PLAN COMMISSION

- a. Ryan Janssen, representing Avery & Birch, for a recommendation for Preliminary Approval of a new building consisting of a three-story salon suite facility, located at 21055 Crossroads Circle.

Strand Associates, Inc.® (Strand) has finished its third review of the plan package for the Avery and Birch Development that was received from the Town on December 28, 2023, for conformance with the Town specifications and general engineering practices. New drawings and a letter describing the revisions were returned to Strand on January 17, 2024, from Jenswold Development (Developer) after Strand's concerns from its January 8, 2024, letter were addressed (shown in the following). A third response letter with submittal was received by Strand from the Town and Developer on February 7, 2024, along with an updated Stormwater Management Plan on February 13, 2024. The most recent Developer responses are included in *italics* and Strand's current comments are in **bold**. Before construction may begin, the contractor shall submit all required permits for the development to the state, Wisconsin Department of Natural Resources, Town, and any other relevant agencies.

CONSTRUCTIO

SITE LANDSCAPING

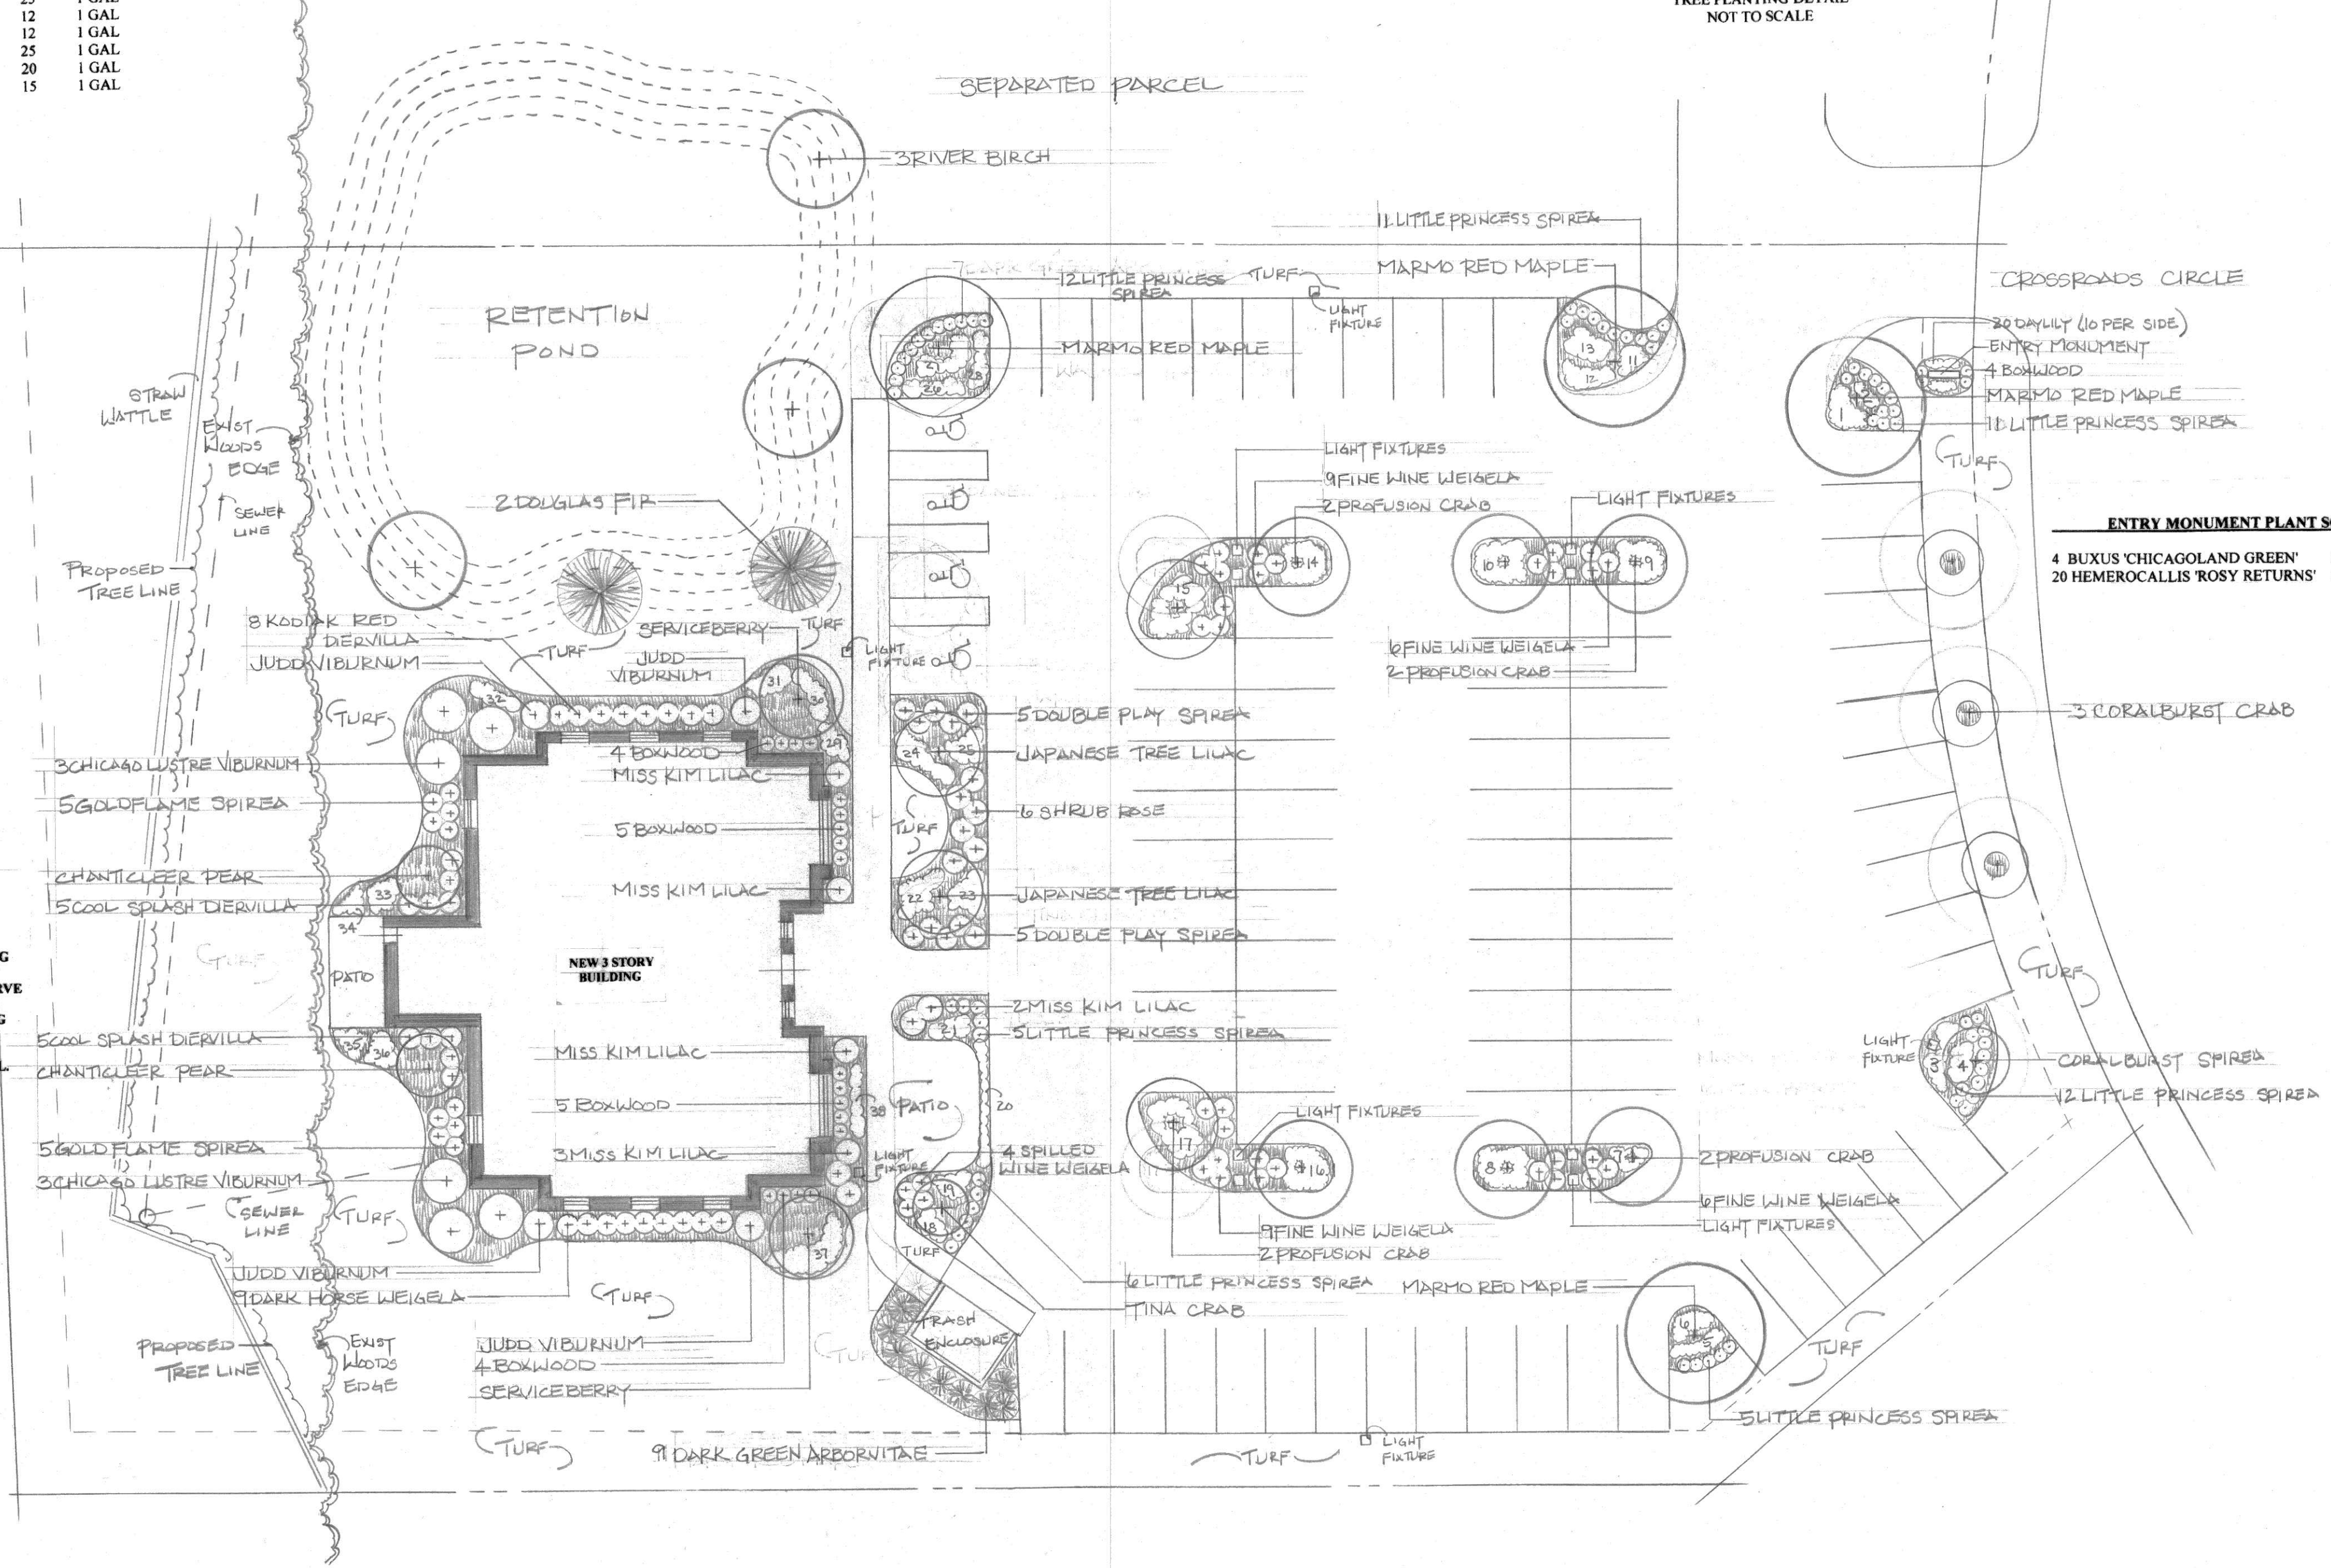
1. Strand's January 8, 2024, Comment—It should be verified that the mature spread of the trees, specifically the Homestead Elm trees, will not extend beyond the lot line (Section 17.02.19.e.).

2. Strand's January 8, 2024, Comment—Please show trees for preservation on future drawings. Also, in accordance with Section 17.02 (6) 19.C, provide information on natural forest or woodland areas and substantiality or quality thereof.

Developer's January 17, 2024, Response—The homestead elm trees have been replaced with coral burst crabapple trees which will not have as large of a mature spread.

Developer's January 17, 2024, Response—The tree removal has been shown and a note has been added to the plans in regard to tree preservation.
